# Planning Officer's Report - LDCA NOVEMBER 2020

**APPLICATION 2020/77** – Proposed Construction of a Prefabricated Steel

Building for Drainage Depot including minor Earthworks for access and construction of the base slab and also a vehicle

# **Diagram 2 Site Plan**

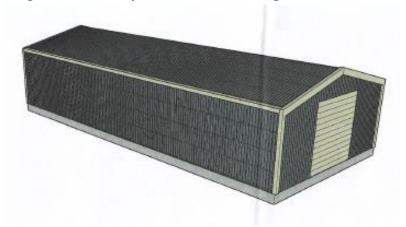
- drawing CSH RH 001: the roof ridge-line is shown higher than the adjacent containers but on the AMD elevational drawing it is shown lower than the containers;

- drawing CSH RH 001: plan and section shows considerable disparity in the relationship between the existing containers and the proposed building, the section shows an earth bank in front of the containers that is propose to be removed, however it appears to be a designed landscape bank to reduce the visual intrusion from distant views;

- similar new bank would be an advantage to do the same for the new building. However the section does not extend v across the full new hardstanding area and so that is not clear and this areas needs additional detail and landscaping;

The slight disparities in the drawing is not a big concern, the important issues that the dimension of the building on the main drawing are correct to determine the height. The 3D impression is assist in the assessment of the impact and details can be slightly distorted, particularly with the imaging of the land terrains. The development could benefit from additional landscaping and this can dealt with as a condition to reduce the visual impact on the landscape.

Diagram 3: 3D Perspective of the Building

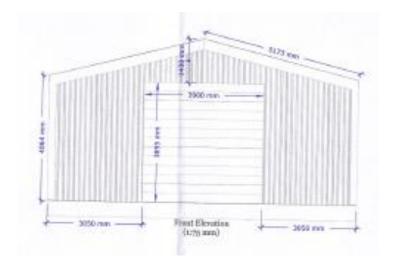
- ensure reduced visual impact on the crest of the hill it would be better if the proposed new roof was lower than the top of the containers, as in the AMD drawing and could this be achieved with a shallower roof pitch, reduced eaves height or reduced road level or a combination or all three;
